ADDENDUM #1

211-231 BANK STREET CONSERVATION PLAN

Applications D02-02-22-0127 / D07-12-22-0188 and plan number 18910

August 2024

Figure 2: SF-1 Conceptual façade support section. Source Art Engineering Inc. August 24.

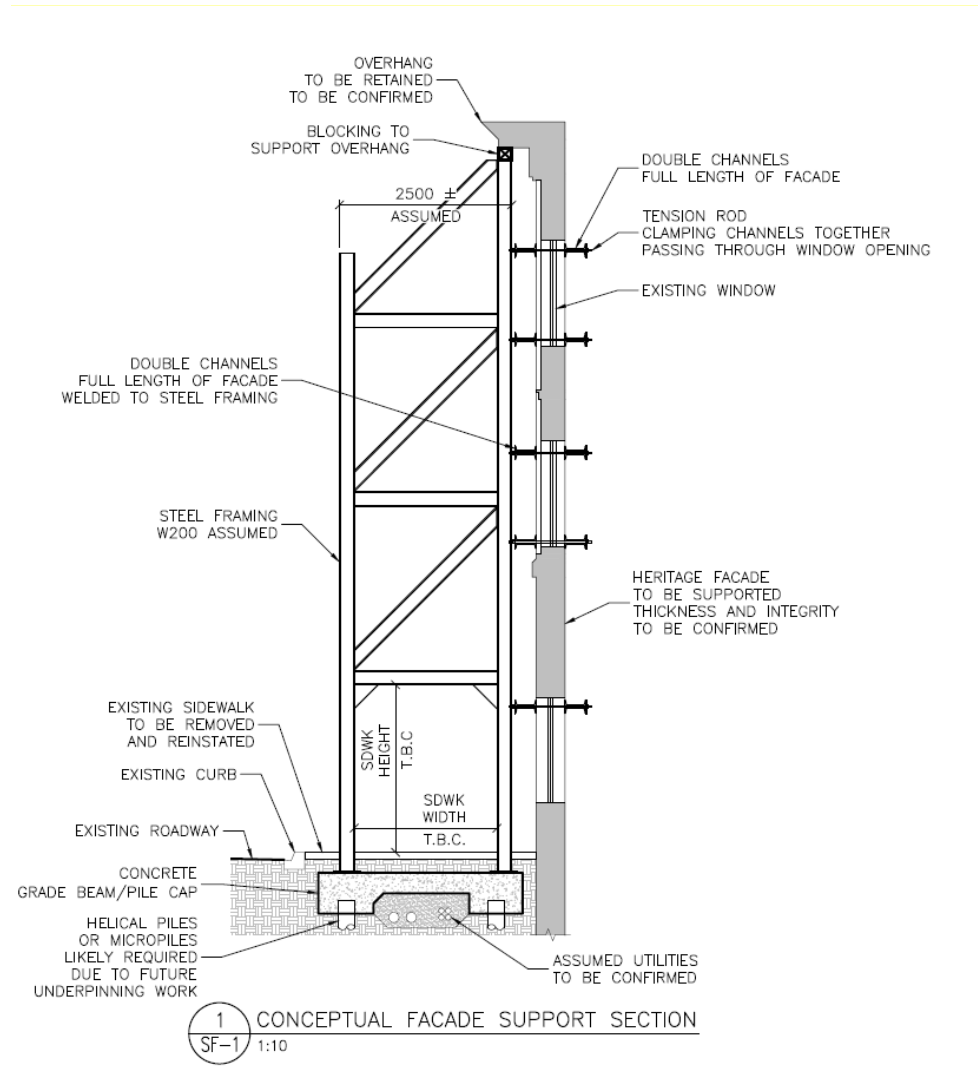
Art Engineering Ltd., a structural engineer licenced in Ontario with a background in masonry conservation, is contracted to prepare specifications for masonry conservation and for the structural shoring specifications. It will outline a strategy and provide direction, ensuring temporary shoring to support the heritage façades with bracing erected on the exterior façade along the street. Art Engineering will provide a detail description of the methodology for shoring the existing buildings from the exterior in the design phase.

The temporary shoring plan and masonry restoration addresses the existing exterior masonry on the first, second, and third storeys of the existing buildings at 211, 215, 219 223, and 231 Bank Street as well as the extensions along 178 Nepean and Lisgar Streets. Portions of the rear façade are being demolished and brick will be salvaged for use in repairs and infill with matching material.

215-217 BANK ST.

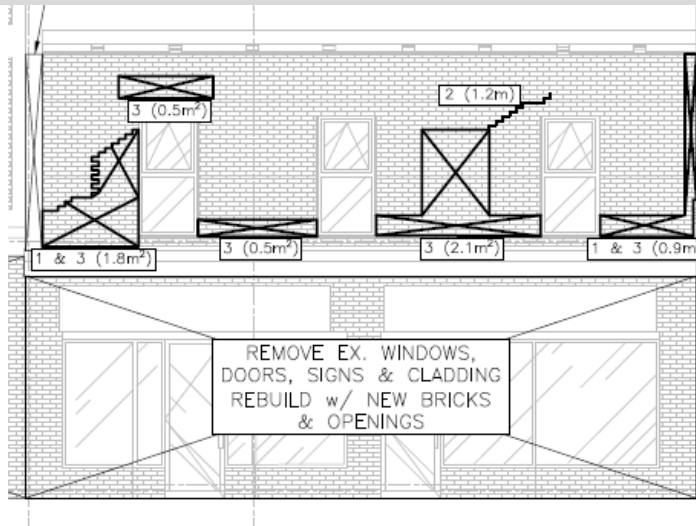
REMOVALS AND INTERVENTIONS OF THE EXISTING BANK STREET FACADE

1. Undertake detailed assessment of the metal cornice. Landings.
2. Assess upper floor brick façade windowsills for damage, undertake detailed assessment of the metal cornice.
3. Remove variegated brick cladding, signage, and storefronts from the ground floor.
4. Infill the gap with salvaged brick, or metal panel between the adjacent buildings.

Bank Street Conservation

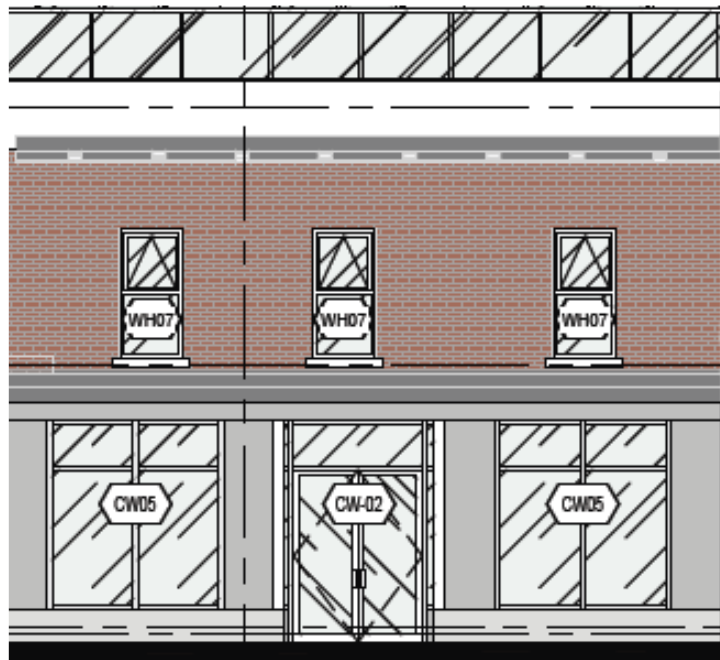
CONSERVATION WORK REQUIRED FOR THE BANK STREET FACADE

1. Repair as necessary the elaborate metal cornice at the roofline.
2. Chemical wash to remove paint from the upper level.
3. Install the ground floor cornice set just below the second-floor windowsills.
4. Selective replacement of damaged/spalling brick, repointing of brick facade, and replacing sills.
5. Replace the 3 second-floor windows with new one-over-one units.
6. Restore the ground floor brick piers at either edge of the building and framing the retail entrance.
7. Insert large glazed commercial storefront into the two bays with recessed flared entrance.
8. Introduce commercial cornice with signboard, knee wall at base, recessed flared entrances. See comparative illustrations.

CONSERVATION WORK REQUIRED FOR THE BANK STREET FACADE

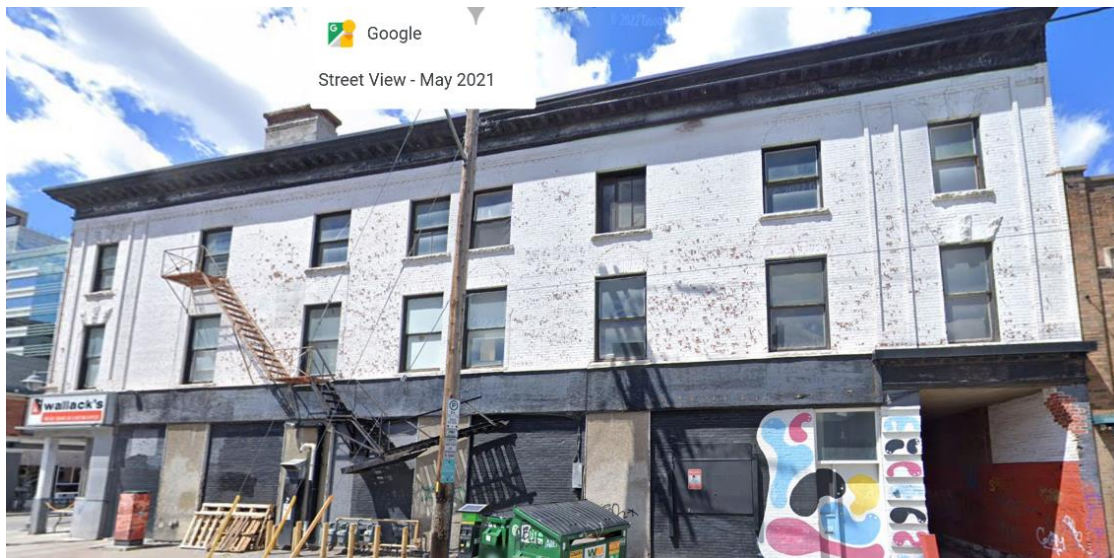
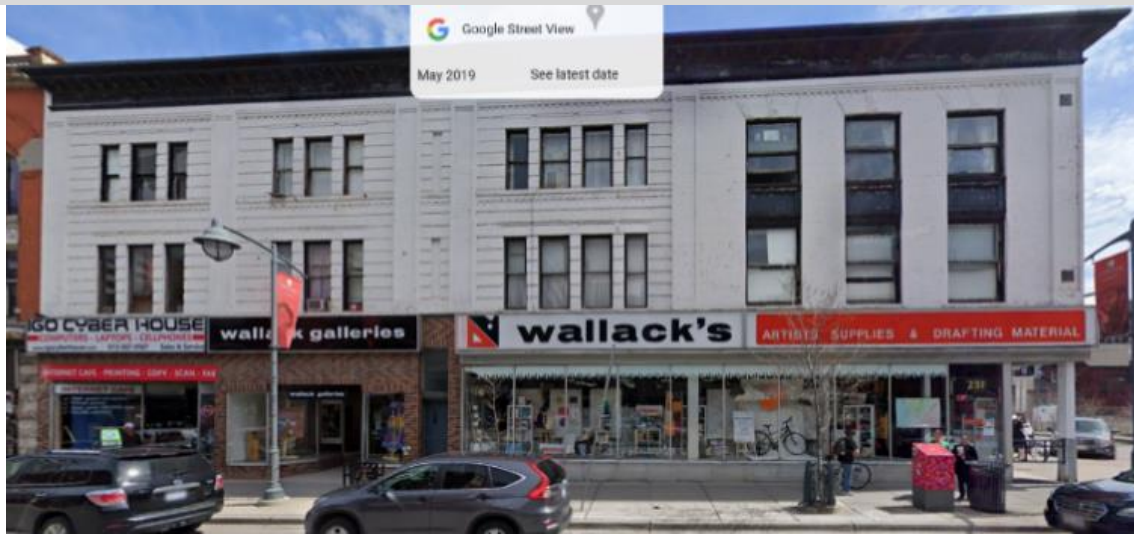
REMOVALS AND INTERVENTIONS OF THE EXISTING BANK STREET FACADE

1. See comparative illustrations.
2. Repair as necessary the elaborate metal cornice and balustrade.
3. Chemical wash.
4. Repair pitted brick in arches, selective repointing of brick, and sills.
5. The two large windows to be replaced with new units retaining the mullion pattern and infill metal panels.
6. Retain and repoint ground floor stone pilasters with a capital to frame the commercial entrance.
7. Insert a support column midway between the columns.
8. Insert large glazed commercial storefronts, setting it back to create a foyer with double entrance doors on the north side.
9. Re-introduce commercial cornice with signboard,
10. Reintroduce knee wall at base.

APPENDIX A: ELEVATIONS: Removals, Intervention & Conservation Work Required Art Engineering Inc.

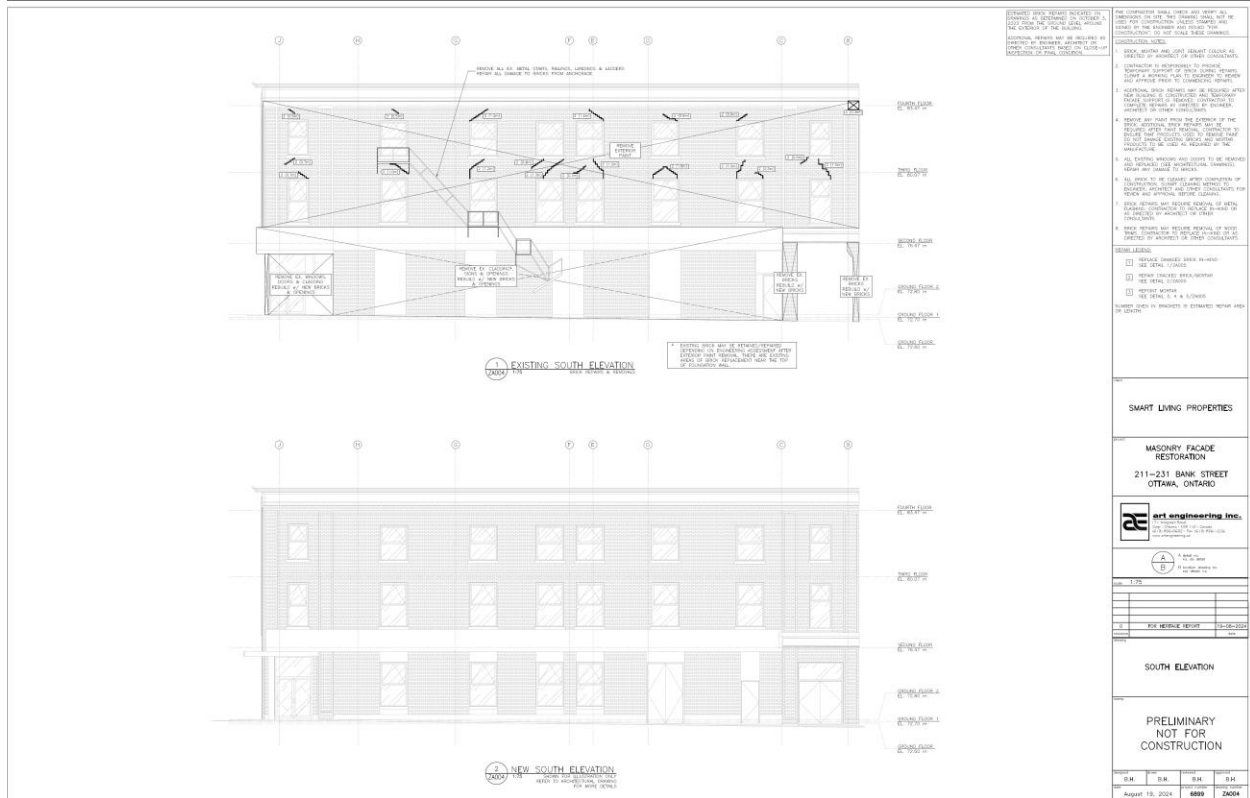
REPOINTING BRICK MASONRY

1. MATERIALS:
MORTAR TO CAN/CSA A179-14, TYPE 'N' FOR ALL MASONRY VENEER, COLOUR AS DETERMINED BY ARCHITECT OR OTHER CONSTANTS:
MORTAR TO BE COMPARABLE WITH EXISTING BRICKS AND MORTAR.

2. SEE MASONRY NOTES FOR ADDITIONAL REQUIREMENTS.
3. DO NOT DAMAGE EXISTING BRICK DURING REPOINTING.
4. FINISH JOINT PROFILE TO MATCH EXISTING.
5. REPOINTING WORK TO BE PERFORMED BY QUALIFIED AND EXPERIENCED STONE MASONS.

6. ENSURE A MINIMUM TEMPERATURE OF 5°C DURING REPOINTING AND FOR A MINIMUM OF 3 DAYS AFTER PLACEMENT OF MORTAR.
7. FINE AGGREGATE TO BE FREE OF SALT AND OTHER IMPURITIES, WELL GRADED SAND.

8. RAKE JOINTS USING MANUAL TOOLS.
9. RAKED JOINT SHALL NOT BE LEFT UNPROTECTED OR UNFILLED FOR MORE THAN TWO WEEKS.
10. CLEAN JOINTS, VOIDS, AND CAVITIES ENCOUNTERED TO BE FREE OF DETERIORATED AND LOOSE MORTAR, DIRT AND OTHER UNDESIRABLE MATERIALS.

11. FLUSH ALL OPEN JOINTS CLEAN WITH COMPRESSED AIR.
12. DAMPEN SURFACES OF JOINT WITH LOW PRESSURE WATER SOAKING AND KEEP DAMP PRIOR TO POINTING. REMOVE ANY FREE STANDING WATER FROM JOINT AND MASONRY SURFACE PRIOR TO POINTING.

13. PACK MORTAR SOLIDLY INTO ALL VOIDS AND JOINTS ENSURING FULL CONTACT WITH BACK AND SIDES OF JOINT AND LEAVING NO VOIDS.
14. TOOL MORTAR WHEN "THUMB PRINT: HARD TO PRODUCE CONCAVE PROFILE.

15. IMMEDIATELY REMOVE MORTAR DROPPINGS FROM SURFACES.
16. SUBMIT ENGINEERED METHODOLOGY AND WORK SEQUENCE FOR PHASES OF MASONRY WORK INCLUDING; REPOINTING, INSTALLATION OF NEW BRICKS, AND TEMPORARY SUPPORTS.
